BOA-23353

BOARD OF ADJUSTMENT CASE REPORT

ACTION REQUESTED: Special Exception to allow an Accessory Dwelling Unit in the RS-3 District (45.031-D); Variance to allow an Accessory Dwelling Unit less than 10-feet behind the Detached House (Sec. 45.030-D.8.b)

APPLICATION NO: **BLDR-112997-2022** (PLEASE REFERENCE WHEN CONTACTING OUR OFFICE)
Location: 3402 W Edison St N
Description: Accessory Structure

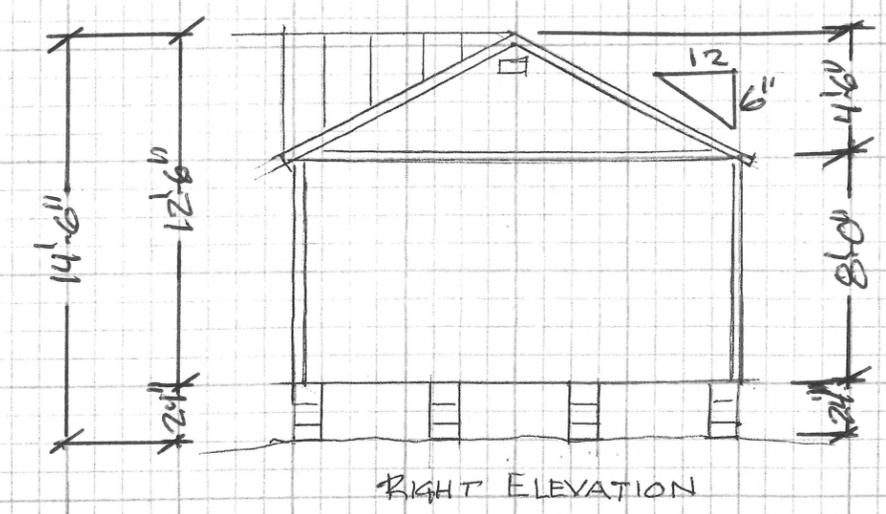
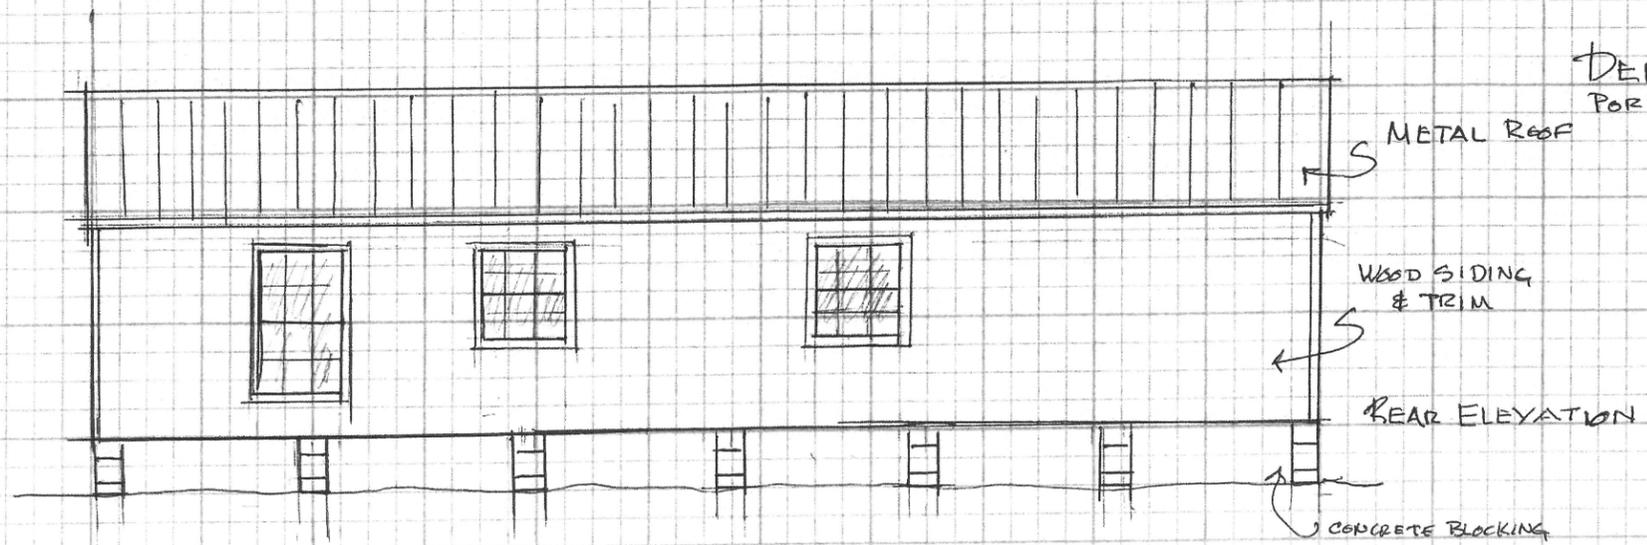
Review Comment: This building must be supported on a continuous footing which must have a depth of at least 18". Revise the plans to show a compliant footing for this building. Alternatively, you may provide sealed, signed, and dated plans from a structural engineer licensed in the state of Oklahoma for a building supported on blocks.

Review Comment: The City of Tulsa requires a minimum of four (4) five-eighths (5/8) inch reinforcement bars to be placed horizontally, two (2) at the top and two (2) at the bottom, in each concrete footing. Show this required footing reinforcement when you submit the wall and footing detail.

Review Comment: The City of Tulsa requires dowels to be placed in the footings per this code section amendment. Show these required dowels on the new wall and footing detail.

FRONT ELEVATION scale 1/4" = 1'-0"

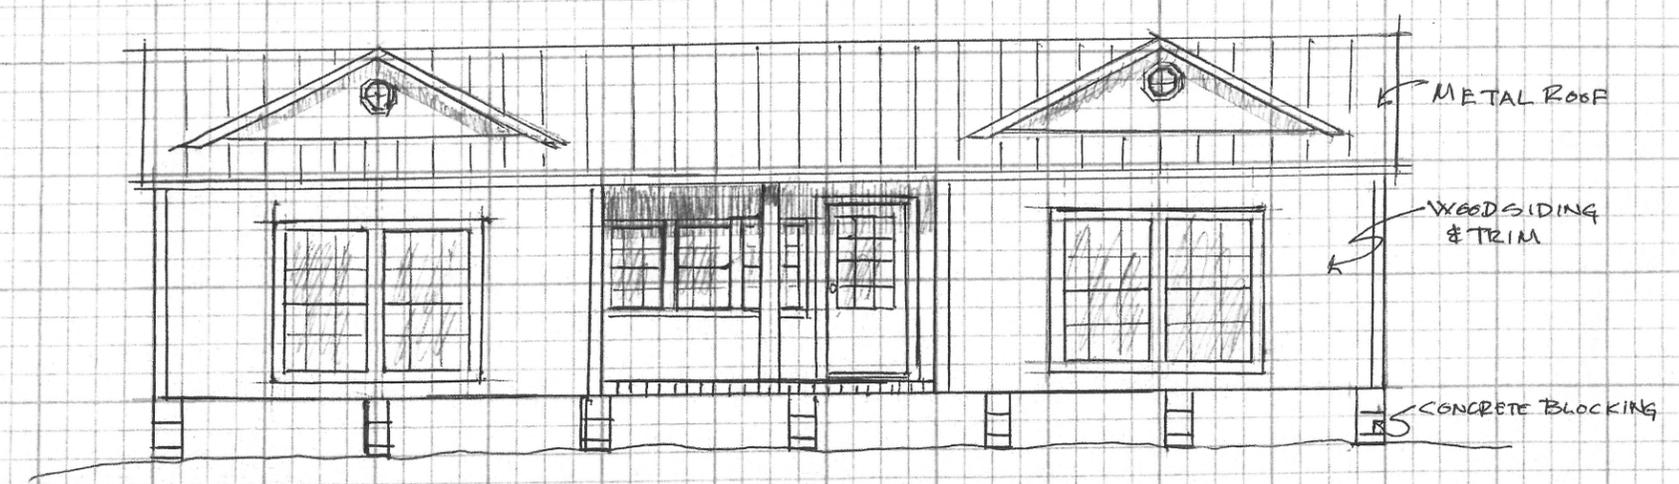
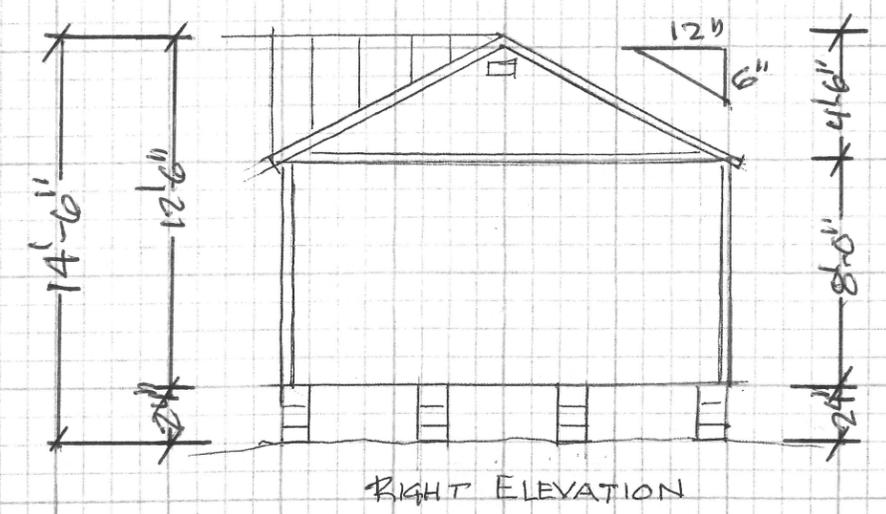
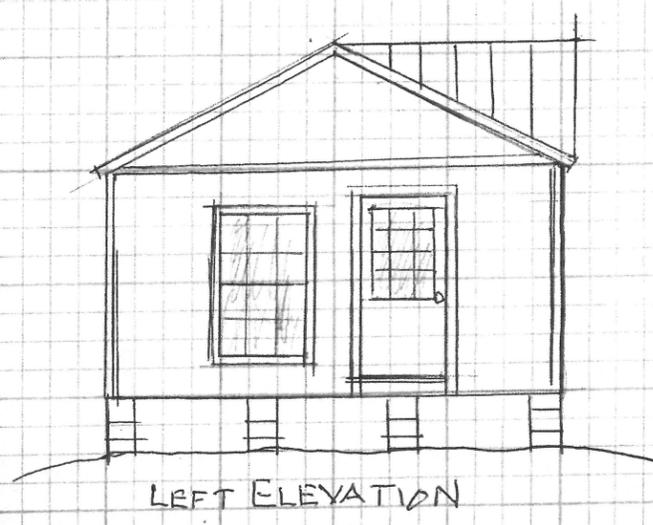
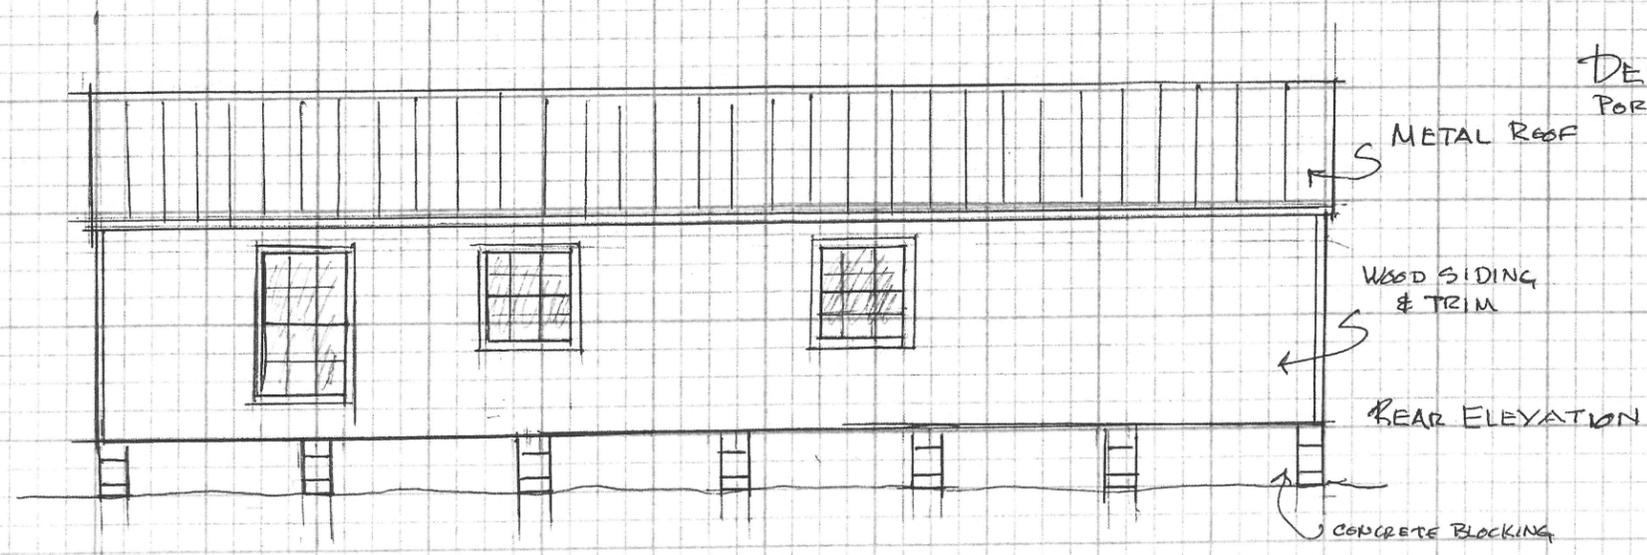
Review Comment: There are several structural details missing from the plans; in addition, a wall cross section drawing is required for new building permit applications. Please provide a wall cross section drawing that shows the required footing details, floor or slab details, wall stud size, wall sheathing, ceiling joist details, rafter size, roof decking, insulation, etc. If this building has an attic, show the method of attic ventilation and the required attic access.

Review Comment: Note that the bathroom window will contain tempered glass or some other type of safety glazing per this code section
- R314.3 Location.** Smoke alarms shall be installed in the following locations: 1.) In each sleeping room. 2.) Outside each separate sleeping area in the immediate vicinity of the bedrooms. 3.) On each additional story of the dwelling, including basements and habitable attics and not including crawl spaces and uninhabitable attics. In dwellings or dwelling units with split levels and without an intervening door between the adjacent levels, a smoke alarm installed on the upper level shall suffice for the adjacent lower level provided that the lower level is less than one full story below the upper level. 4.) Smoke alarms shall be installed not less than 3 feet (914 mm) horizontally from the door or opening of a bathroom that contains a bathtub or shower unless this would prevent placement of a smoke alarm required by Section R314.3.

Review Comment: Modify the plans to show smoke alarms inside and outside of the bedroom, in the immediate vicinity of the bedroom, per this code section.
- R315.3 Location.** Carbon monoxide alarms in dwelling units shall be installed outside of each separate sleeping area in the immediate vicinity of the bedrooms. Where a fuel-burning appliance is located within a bedroom or its attached bathroom, a carbon monoxide alarm shall be installed within the bedroom.

Review Comment: Modify the plans to show a carbon monoxide alarm outside of the bedroom, in the immediate vicinity of the bedroom, per this code section. Combination smoke/carbon monoxide alarms may be used.
- R403.1 General.** All exterior walls shall be supported on continuous solid or fully grouted masonry or concrete footings, crushed stone footings, wood foundations, or other approved structural systems which shall be of sufficient design to accommodate all loads according to Section R301 and to transmit the resulting loads to the soil within the limitations as determined from the character of the soil. Footings shall be supported on undisturbed natural soils or engineered fill. Concrete footing shall be designed and constructed in accordance with the provisions of Section R403 or in accordance with ACI 332.

Review Comment: Modify the plans to show this required foundation anchorage into the treated sill plates when you submit the wall and footing detail.
